To: T10 Technical Committee  
From: Rob Elliott, HP (elliott@hp.com)  
Date: 5 November 2005  
Subject: 05-309r1 SAS-2 Add device name to IDENTIFY address frame

**Suggested changes**

Figure 1 — SAS domain class diagram [\[modified\]](#)

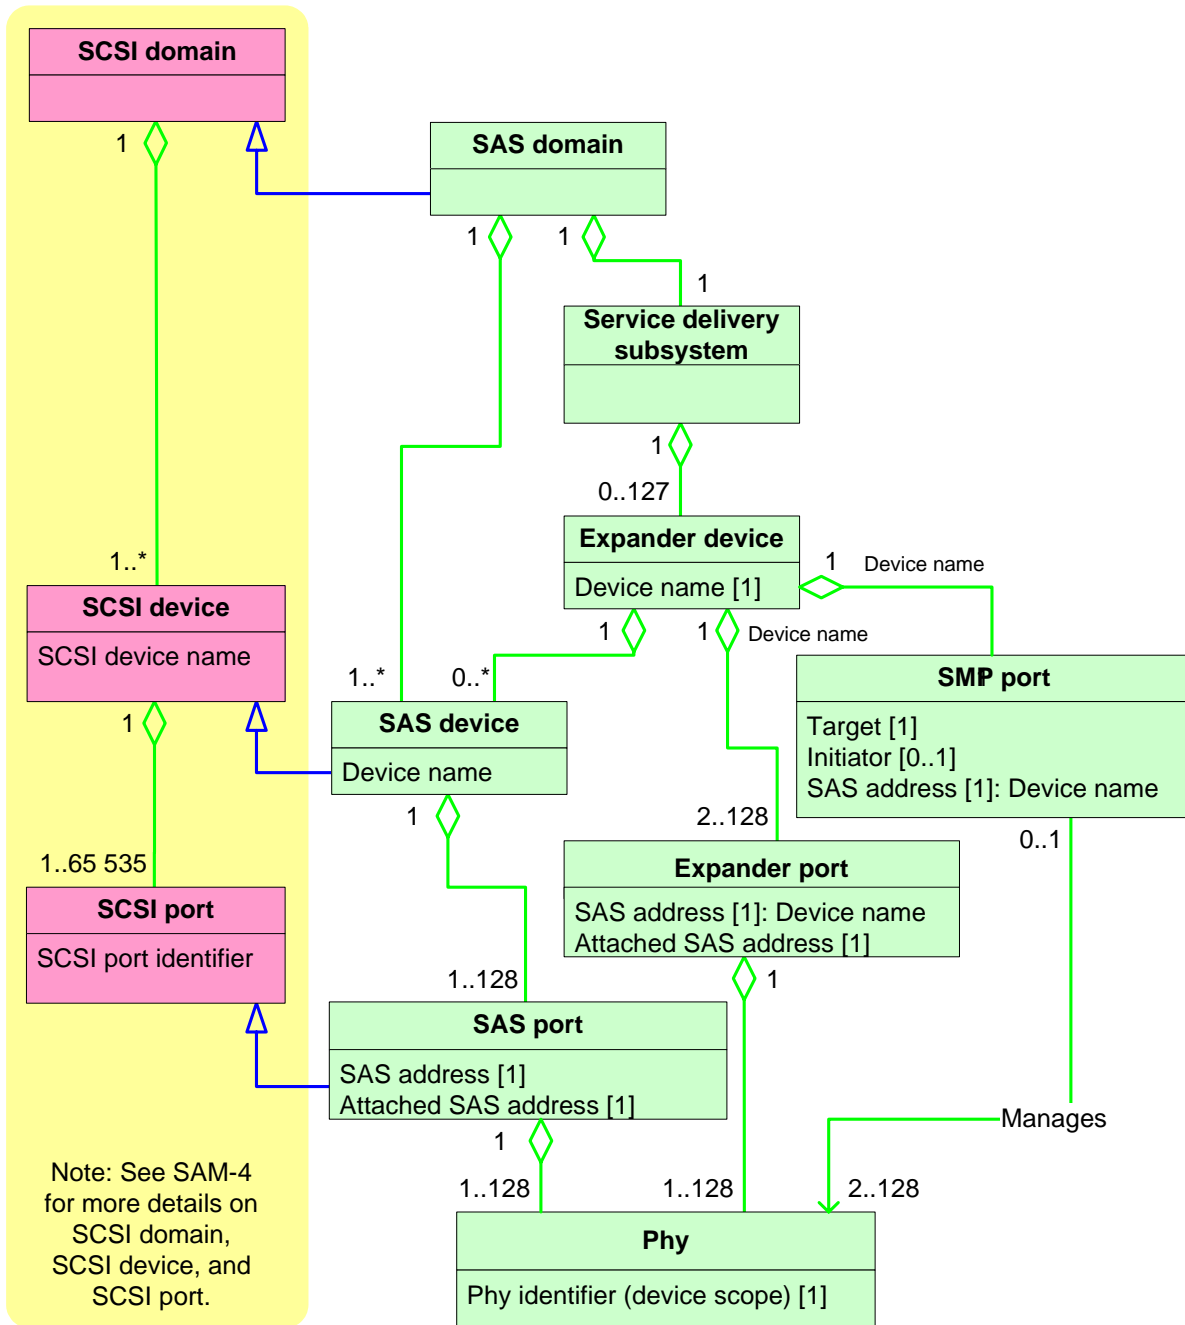
Figure 1 shows the class diagram for a SAS domain, showing the relationships between SAS domain, SCSI domain, service delivery subsystem, expander device, expander port, SAS device, SCSI device, SAS port, SCSI port, and phy classes. Not all attributes are shown.

Editor's Note 2: Figure needs work - how to show inherited attributes that change names?
